Appendix O

Potential Project Design Modifications Assessment

Figure O-1 Design Modifications Layout

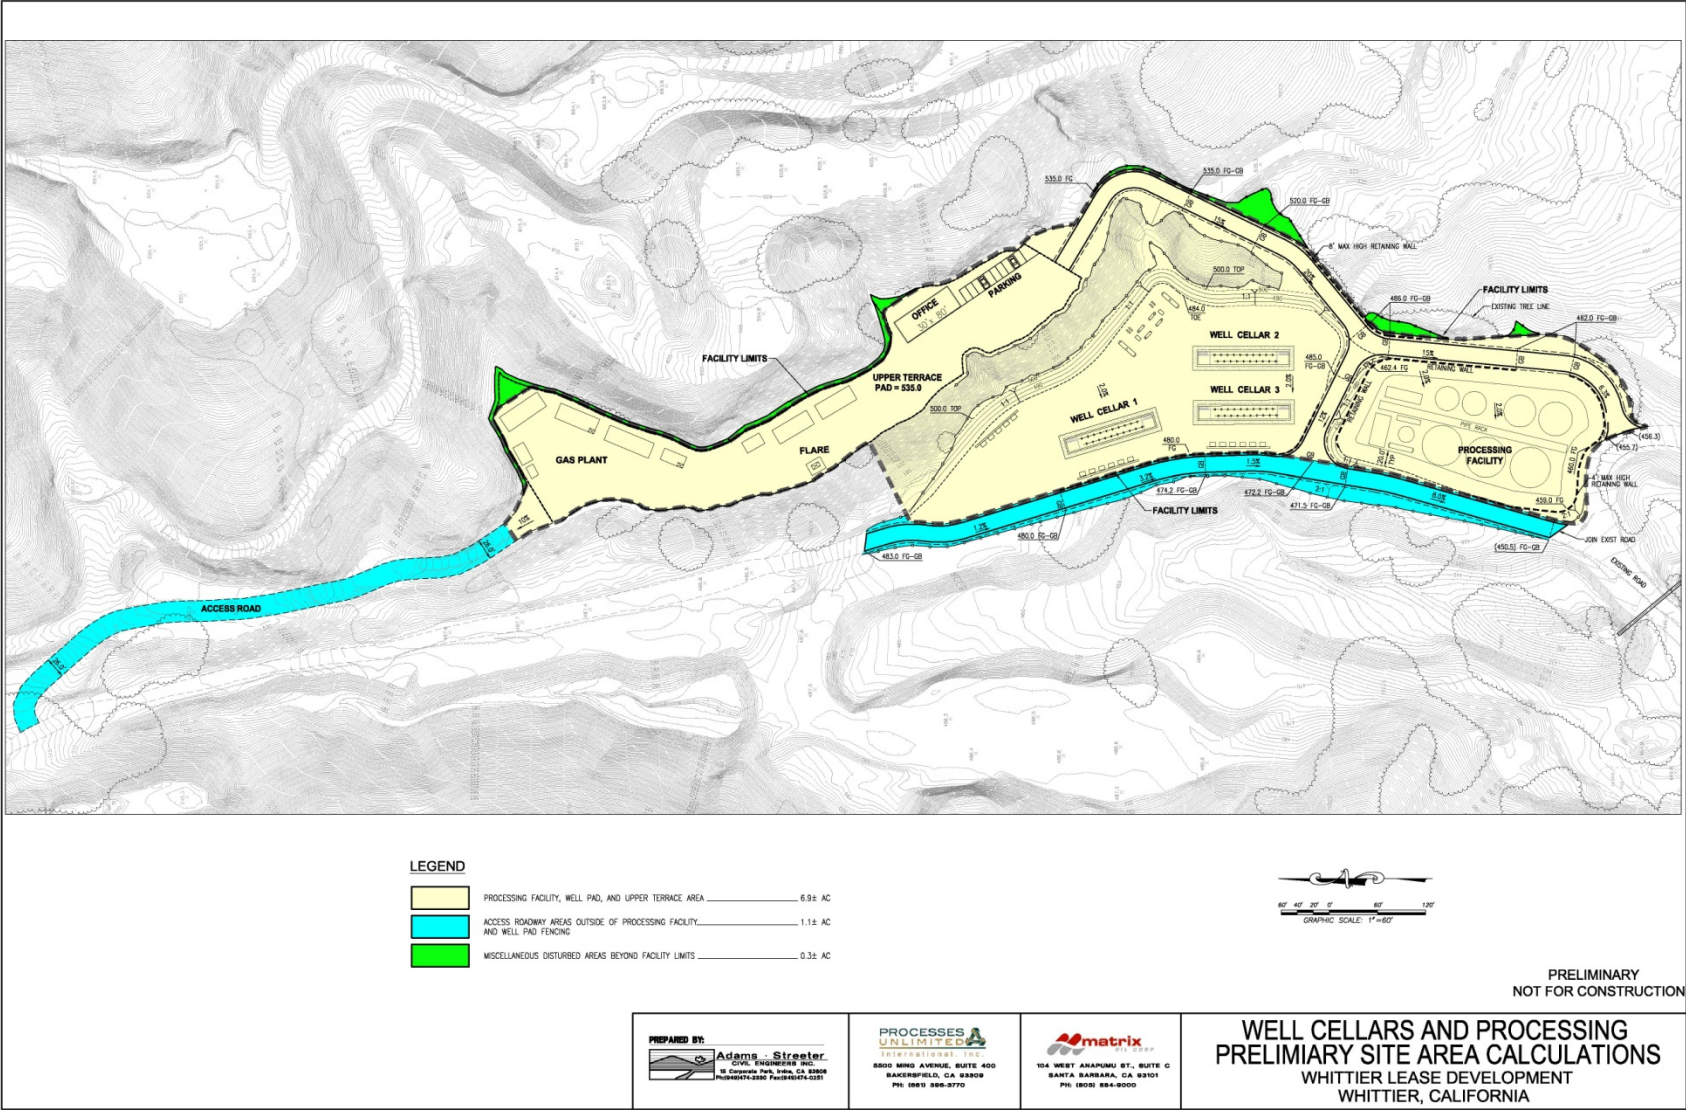
Matrix has proposed the following changes to the original Project design. Changes have focused on redesigning the layout and the amount of grading required for the Project pads with the primary objective to reduce the number of truck trips during project construction.

The revised site plan design described in Figure O-1 and O-2 attempts to achieve the following:

1. Overall cuts and fills for dirt work are balanced, i.e., no required soil export or berm installations;
2. Eliminates the collateral impact to the surrounding area outside the 7 acre facility to minimize footprint and rehabilitation acreage, i.e. 27 acres impact with berms and slope-backs;
3. Significant reduction in visual impacts from the Preserve (eastern side) by not sloping back hillsides and retaining the large eucalyptus grove to the southeast;
4. Eliminates retaining walls in the 30-40' category. Retaining walls will be held to heights of 8-10 feet, thus substantially reducing cost and safety concerns;
5. Final consolidated facility area is 6.9 acres. The redesign loses about one acre of usable area inside the fence because the natural slope between the upper tier and the wellpad area is retained.

The expectation is that the design revisions would reduce the amount of grading and result in a reduced overall impact area to the Preserve. Under the modification, the amount of earth moved from the site during Project grading would be reduced from 147,000 yds³ to zero. The duration of grading would be cut in half, from 24 weeks to 12 weeks.

Figure O-2 Design Modification Layout with Proposed Project Overlay

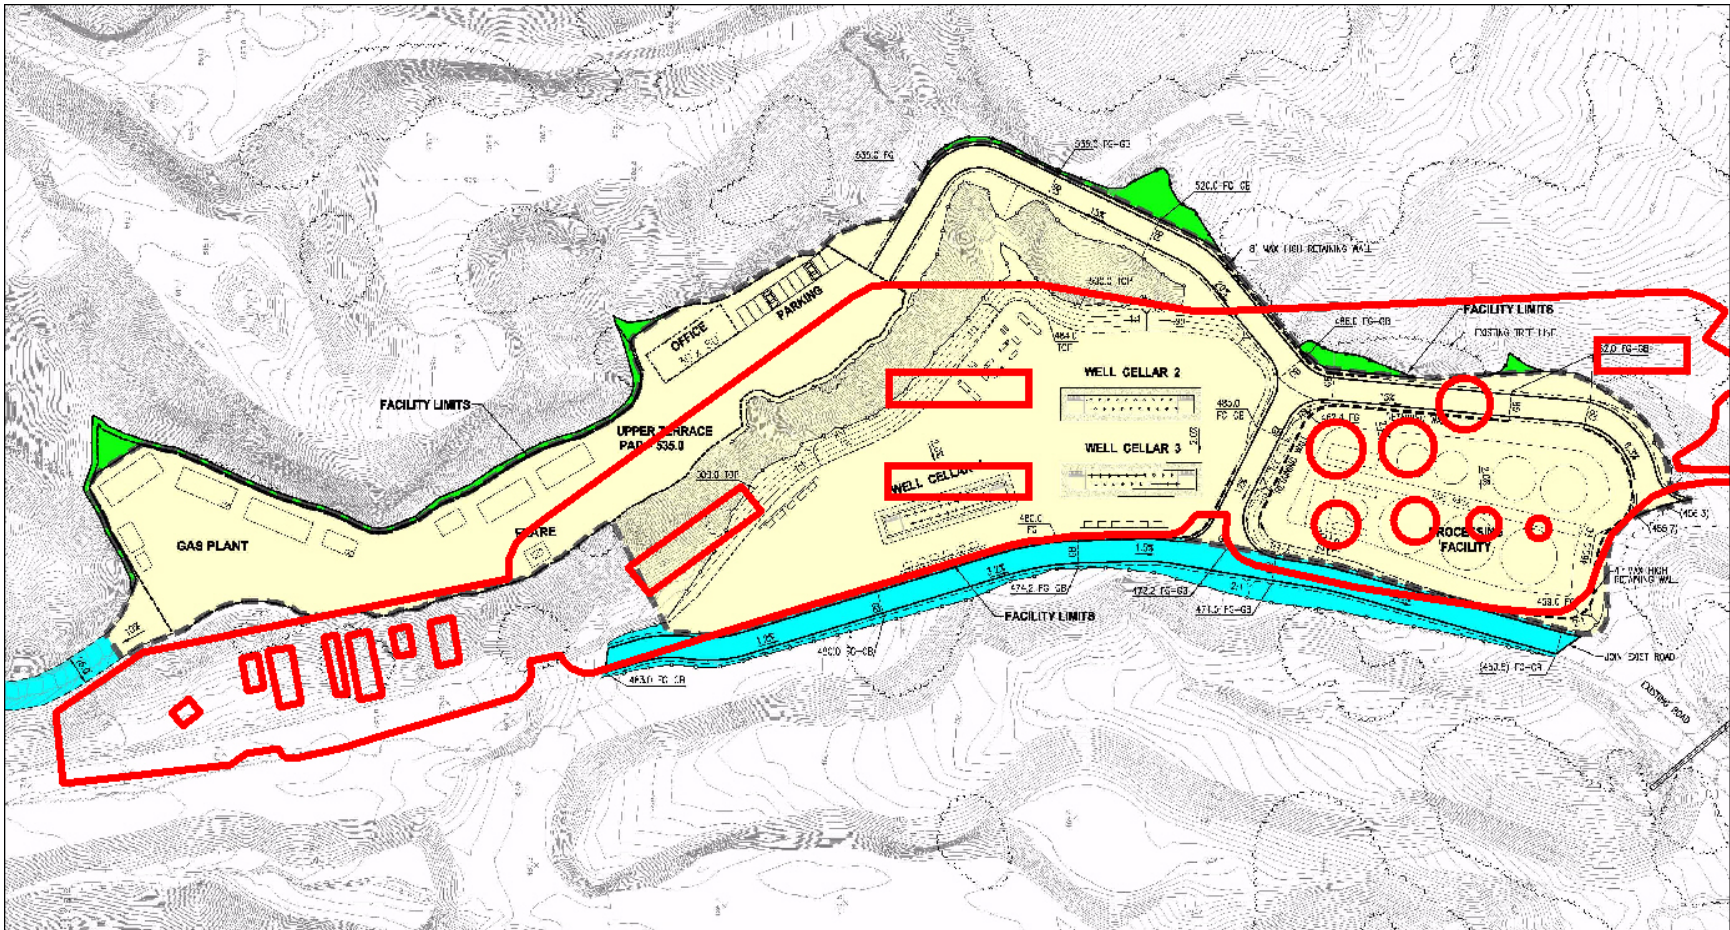
Figure O-1 shows the design modification layout and Figure O-2 shows the design modification with the proposed Project, as described in section 2.0 of the EIR, overlaid on top. For more information on the proposed Project equipment locations, please see Figure 2-7 in section 2 of the EIR and Appendix A.

Note: Please see Figure 2-7 in Section 2 of the main EIR for the location of the proposed Project components (in red in the figure).
